**NASSCO / NSRP ASE Project**

Demonstration of Enhanced Filtration  
for  
Treatment of Shipyard Storm Water

**DESIGN REPORT**

Barry Kellems facilitated the review meeting, which lasted from 9 am to 11:30 am. The following comments on the Draft Design Report were received from Gary Minton (GM), Jean Nichols (JN), Todd Thornburg (TT) and Jim Lenhart (JL). Also included below is the resolution of each comment based on the review meeting

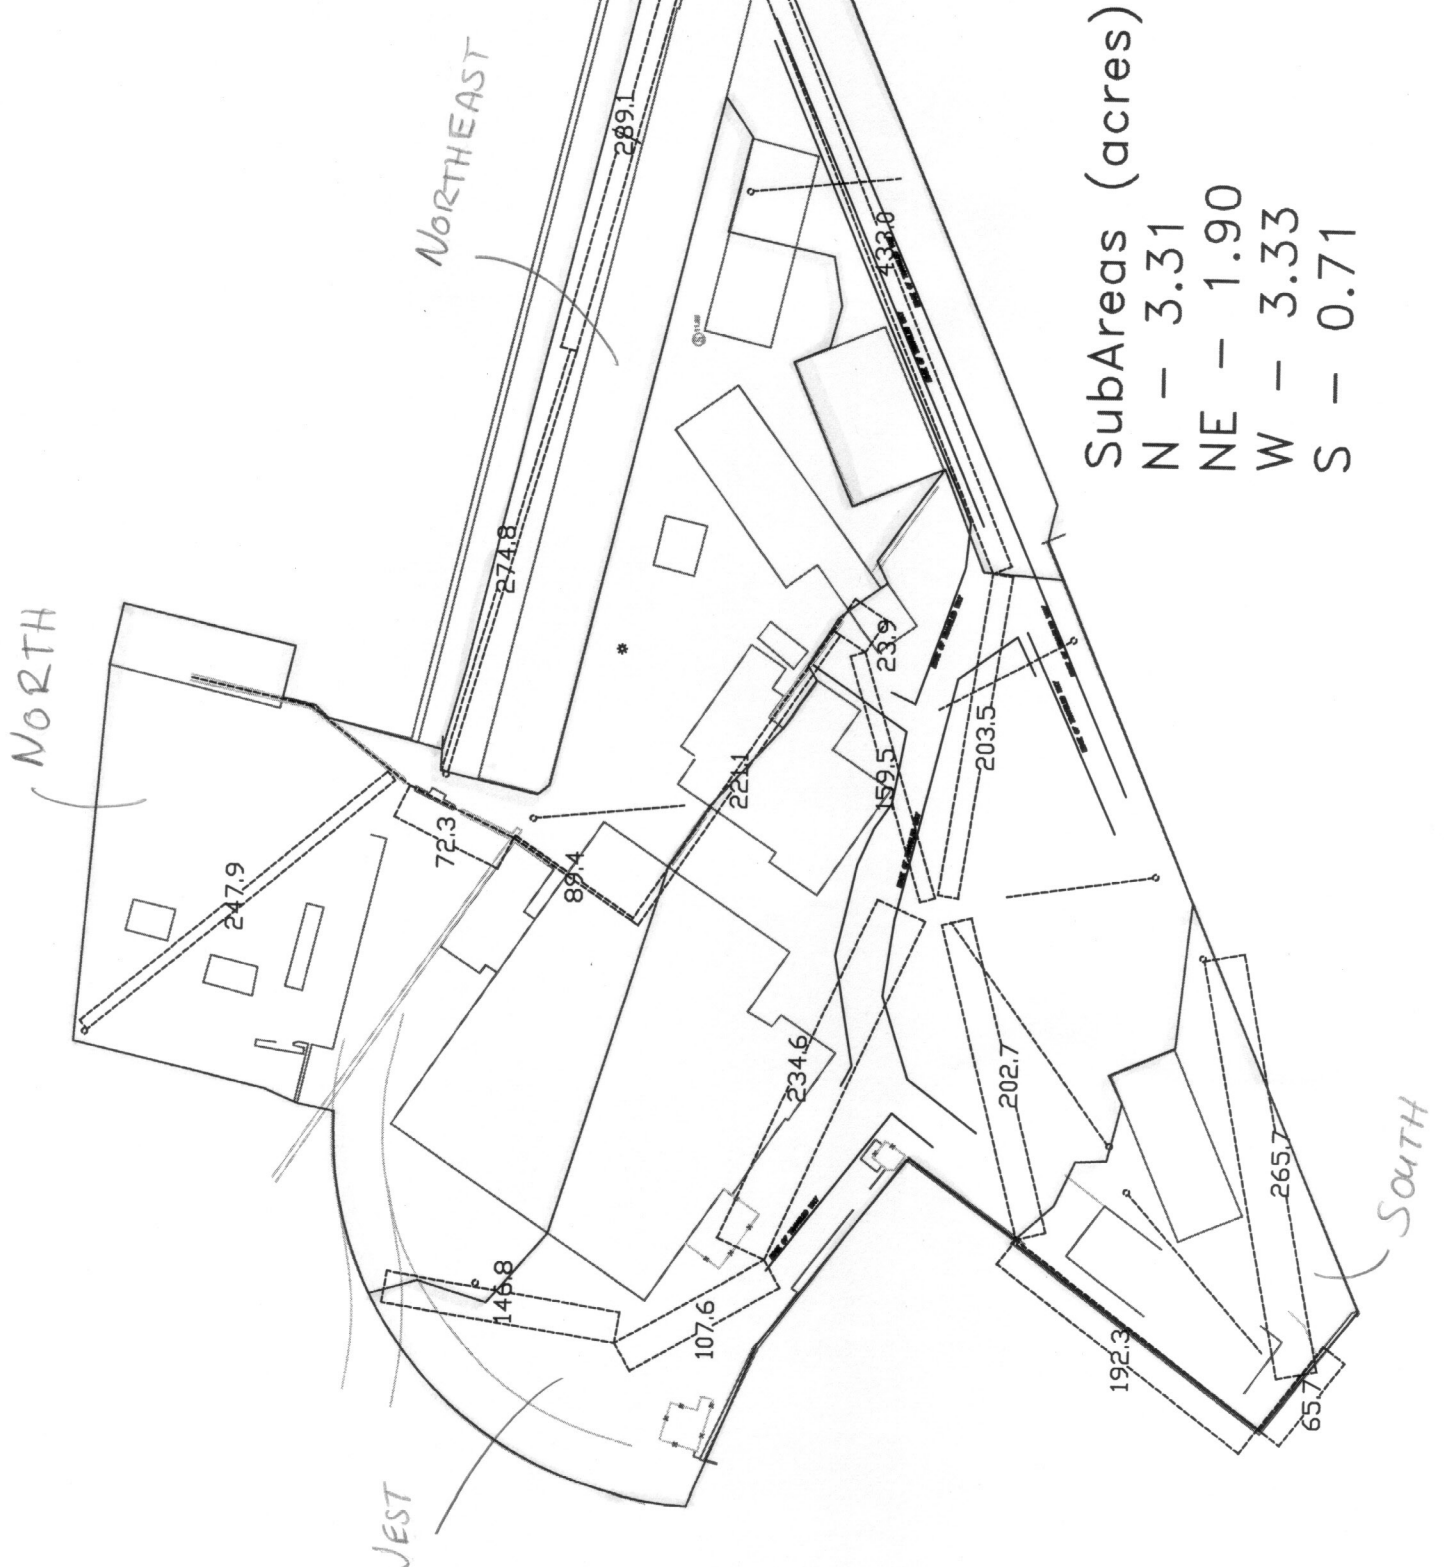
TT4. I don't see a vault height dimension on Figure 7.

Response: Comment Accepted - Dimensions will be added.
